September 26, 2025

ADDENDUM NO. 2

DNR-250004 GREAT COUNCIL OBSERVATION TOWER

L200

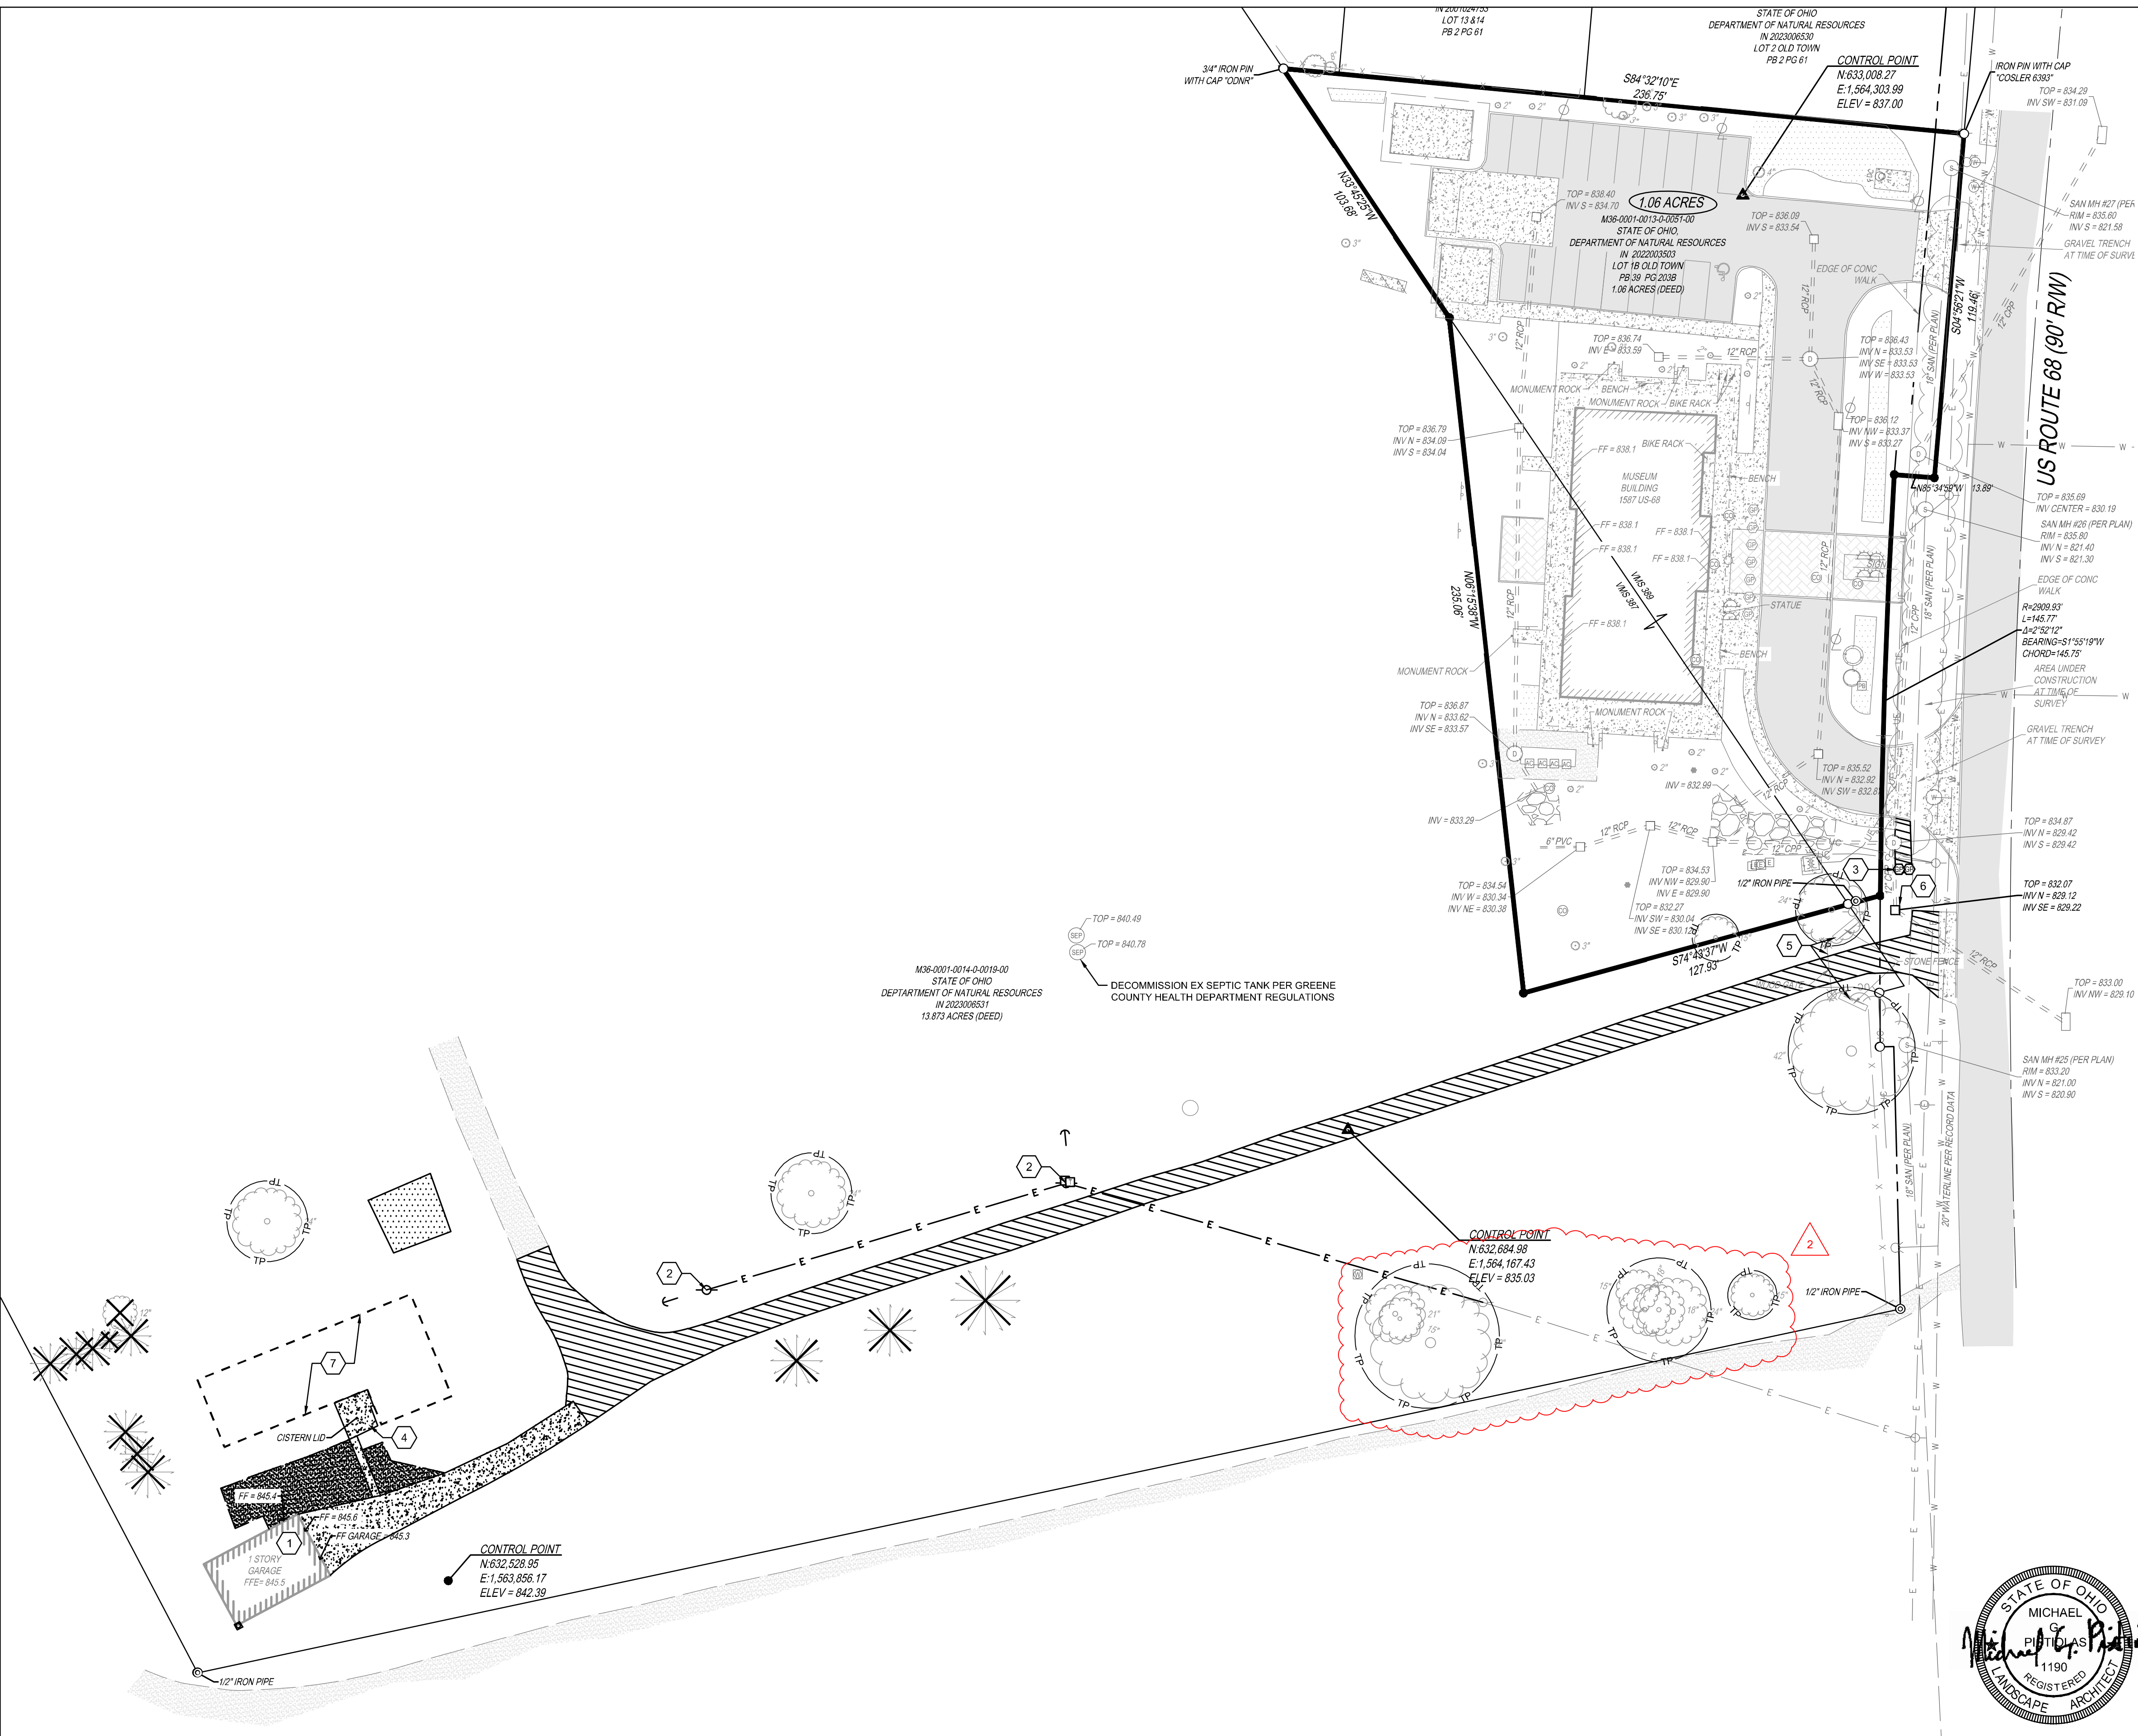
ITEM 8 L200 – DEMOLITION PLAN

Added tree protection to existing trees within contractor laydown and parking area.

ITEM 23 Q: CODED NOTE 7 ON L200 INDICATES LIMITS OF EXISTING FILL THAT NEEDS TO BE REMOVED AND REPLACES. THE GEOTECHNICAL REPORT INDICATES BORING B-02-25 ENCOUNTERED FILL MATERIAL DOWN TO 3'-0". THIS BORING LOCATION IS OUTSIDE OF THE LIMITS OF CODED NOTE 7 AND WITHIN THE NEW OBSERVATION TOWER FOOTPRINT. WITH THE MAT FOUNDATION BEING 3'-6" IN DEPTH IS THERE NO CONCERN OF HAVING TO REMOVE AND REPLACE EXISTING FILL IN THIS LOCATION OR SHOULD SOMETHING BE INCLUDED? IF SO CAN A QUANTITY OR ALLOWANCE BE PROVIDED?

A: Unit Price U-1 in the bid form is set up for the contractor to include a per cubic yard unit price for the removal and replacement of existing fill.

L400

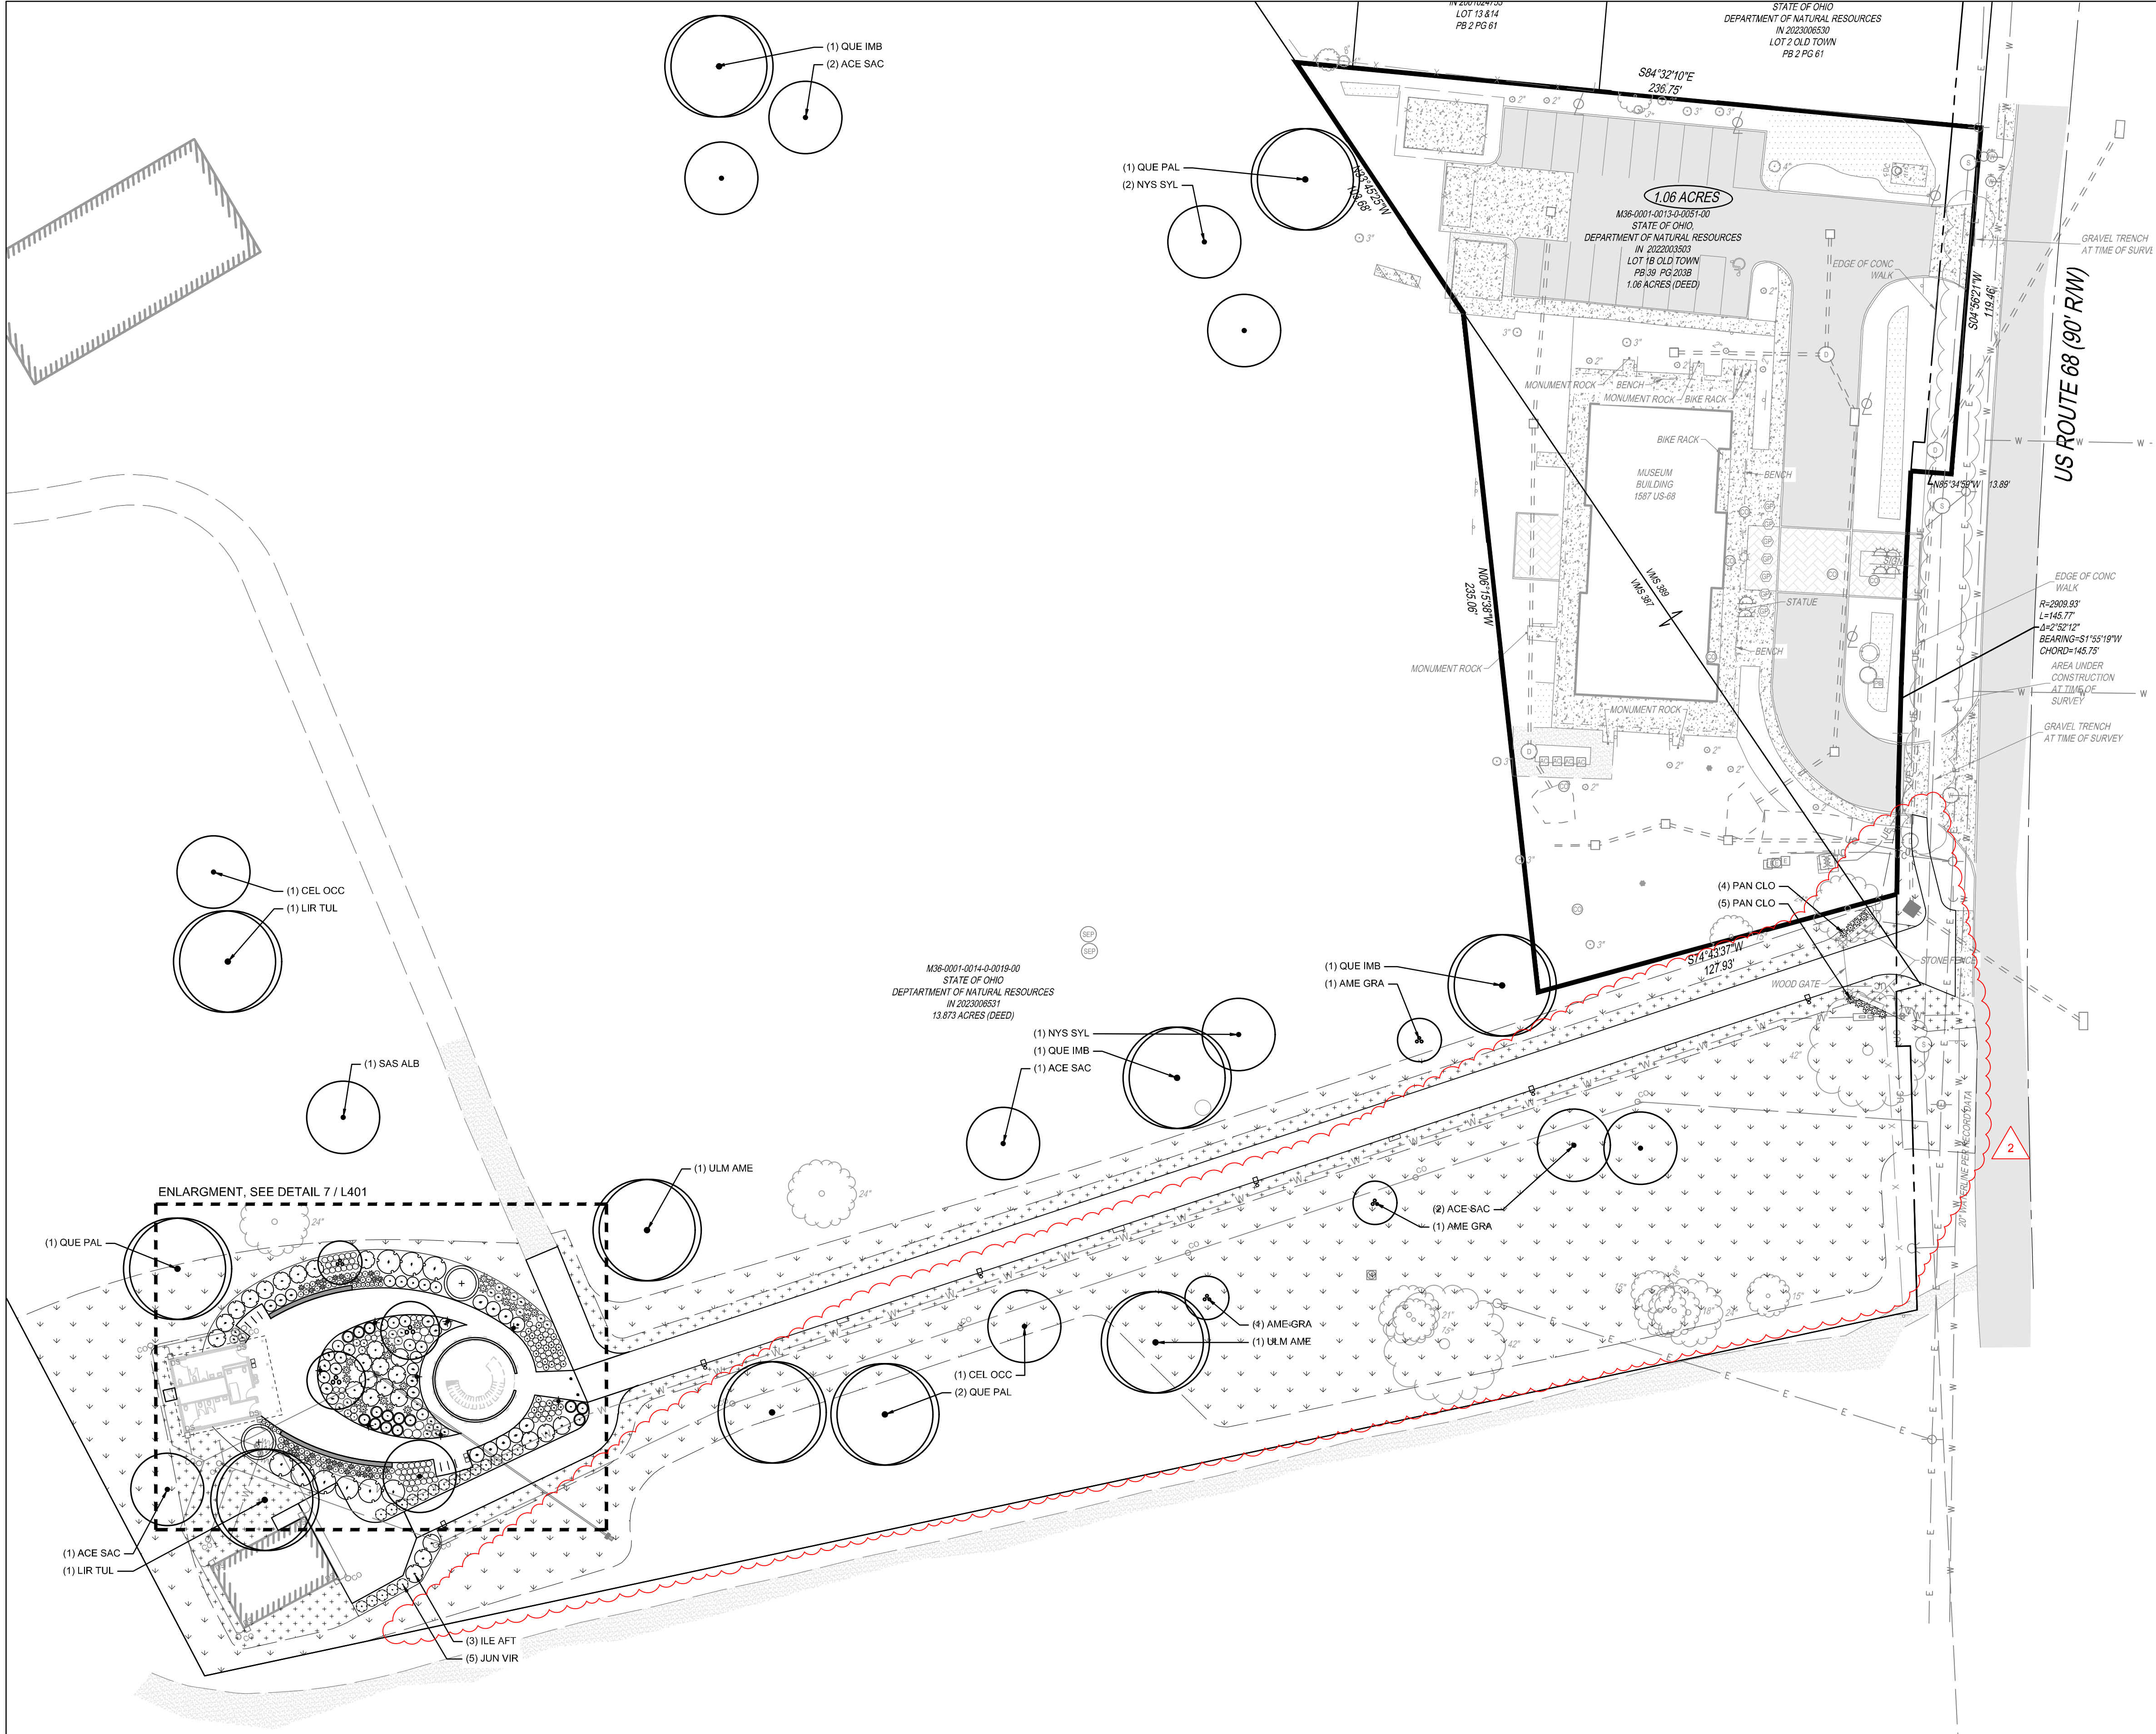
ITEM 10 L400 – PLANTING PLAN

Revised seeding area to include contractor parking and laydown area.

4 Eave Detail
1 1/2" = 1'-0"

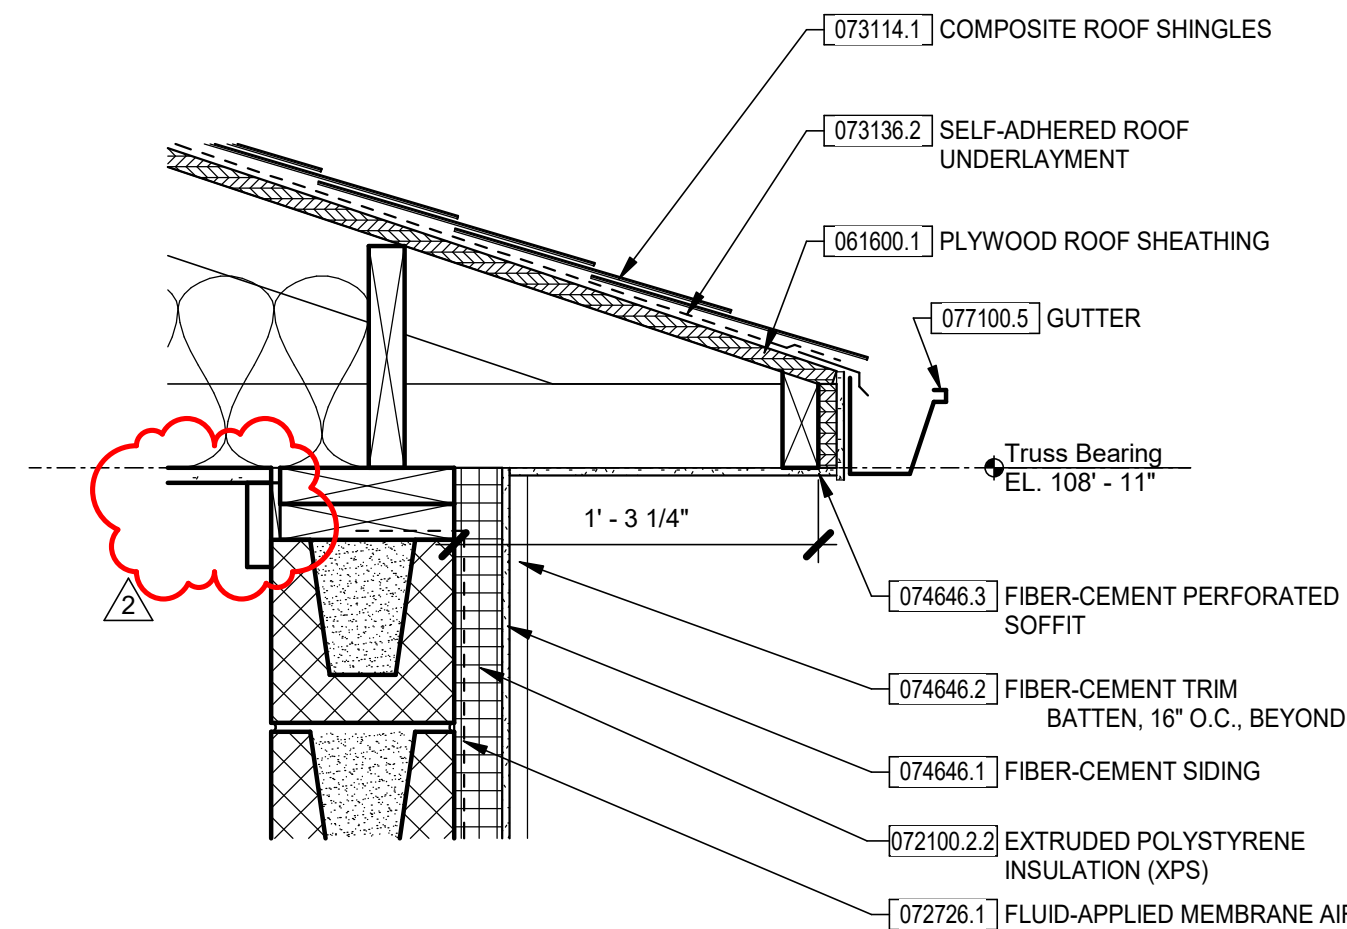
ITEM 13 R-A2 – ROOF PLAN AND SECTIONS

Revised detail 4 – Eave Detail to correctly show ceiling attached to underside of roof structure.

ITEM 15 Q: PAGE R-A2 DETAIL 4. IT APPEARS THAT THE PVC CEILING IS 3" LOWER FROM THE BOTTOM OF THE TRUSSES. SHOULD WE INCLUDE FRAMING BETWEEN THE TRUSSES AND THE PVC OR SHOULD WE PLAN TO ATTACH THE PVC TO THE BOTTOM OF THE TRUSSES?

A: PVC should be attached to the bottom of the trusses. Detail has been updated.
